[Docket No. FAA-2025-0618; Project Identifier AD-2024-00637-T; Amendment 39-23280; AD 2026-05-07]

Airworthiness Directives; The Boeing Company Airplanes

Final rule.

Figure 1 to Paragraph (h)(4)—Cap Seal Minimum Thickness (All Dimensions in Inches)

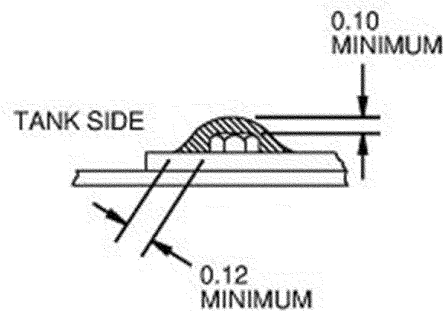
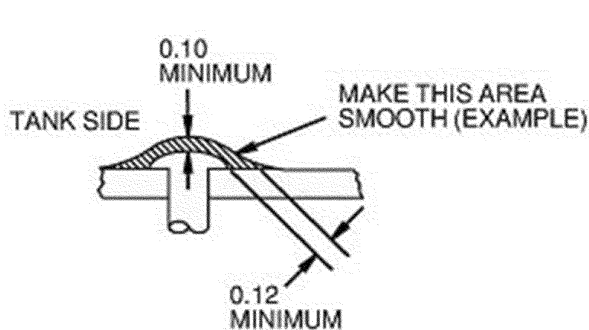
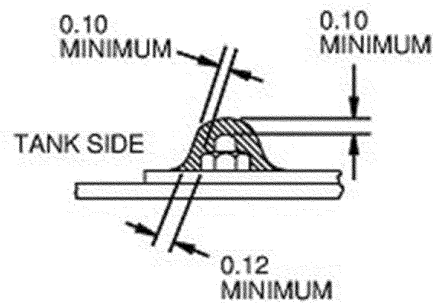
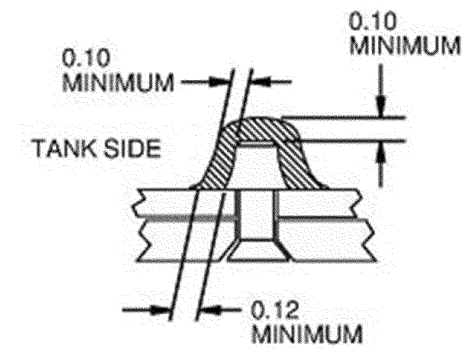
Boeing requested that the FAA remove paragraph (h)(3) and figure 1 from the proposed AD. Boeing stated Boeing Alert Requirements Bulletin 767-57A0148 RB, dated October 10, 2024, refers to section 28-11-00 of the 767 Aircraft Maintenance Manual (AMM) (i.e., 767 AMM 28-11-00) for the cap sealing procedure, and the AMM contains the same cap seal minimum thickness specified in figure 1 to

paragraph (h)(3) of the proposed AD. Boeing asserted that deleting the proposed requirement would prevent duplication of data and potential questions from operators.

Alternatively, Boeing requested the FAA revise paragraph (h)(3) of the proposed AD to clarify that the requirement applies to in-tank fastener cap sealing only and add a note to refer to 767 AMM 28-11-00 as an acceptable cap sealing procedure for in-tank fasteners. Boeing stated this clarification would prevent potential questions from operators and eliminate conflicting cap sealing requirements for out-of-tank fasteners.

FedEx requested that the FAA remove figure 1 and revise paragraph (h)(3) of the proposed AD to require application of the cap seals to wing tank fasteners internally, in accordance with section 51-20-05 of the 767 Structural Repair Manual (SRM) (*i.e.*, 767 SRM 51-20-05). FedEx stated the exception in paragraph (h)(3) of the proposed AD would result in multiple requirements for cap sealing of fasteners internal to the fuel tank, depending on the task being worked. FedEx also stated that the exception is overly general and should be specific only to cap seals internal to the fuel tank. FedEx noted fasteners that penetrate the 767 fuel tank are subject to Critical Design Configuration Control Limitations (CDCCLs) to ensure the lightning, fault current, and hot short protection requirements of Airworthiness Limitation (AWL) 28-AWL-08 are met. FedEx also noted that AWL 28-AWL-08 specifies no additional FAA Oversight Office approval is required if the repair or alternation is accomplished using 767 SRM procedures.

The FAA agrees that the cap sealing requirement of paragraph (h)(4) of this AD (corresponding to paragraph (h)(3) of the proposed AD) does not apply to fasteners outside the fuel tank. Accordingly, the FAA has revised paragraph (h)(4) of this AD to clarify the requirement applies only to fasteners, fastener heads, and fastener threads and collars inside the fuel tank.

The FAA disagrees with Boeing's request to remove the exception or add a note to refer to 767 AMM 28-11-00 as an acceptable procedure for the cap sealing required for in-tank fasteners. Boeing Alert Requirements Bulletin 767-57A0148 RB, dated October 10, 2024, already refers to 767 AMM 28-11-00 as an acceptable procedure, so including such a note in this AD is unnecessary. Further, referencing material as an accepted procedure does not make the actions in the material mandatory. Therefore, the FAA has determined that the exception in paragraph (h)(4) is necessary to ensure the cap sealing procedures are enforceable.

As stated previously, the FAA agrees that the cap sealing requirement does not apply to fasteners outside the fuel tank and has revised paragraph (h)(4) of this AD accordingly. However, the FAA disagrees with the commenter's request to require that the cap sealing for in-tank fasteners be done in accordance with 767 SRM 51-20-05 because the SRM refers to 767 AMM 28-11-00 for sealing of fuel tank repairs. Referring to 767 AMM 28-11-00 does not make the actions in that material mandatory, and the FAA has determined that the requirements in paragraph (h)(4) of this AD must be accomplished. Further, the FAA disagrees that the exception will result in multiple requirements for cap sealing of fasteners internal to the fuel tank because the 767 AMM 28-11-00 contains the same procedures as the requirements of figure 1 to paragraph (h)(4) of this AD. The FAA has not changed the AD in this regard.

(4) During application of any cap seal to a fastener, fastener head, and fastener threads and collars inside the tank, as required by this AD, the cap seal must be applied with a thickness equal to or greater than the dimensions specified in figure 1 to paragraph (h)(4) of this AD.
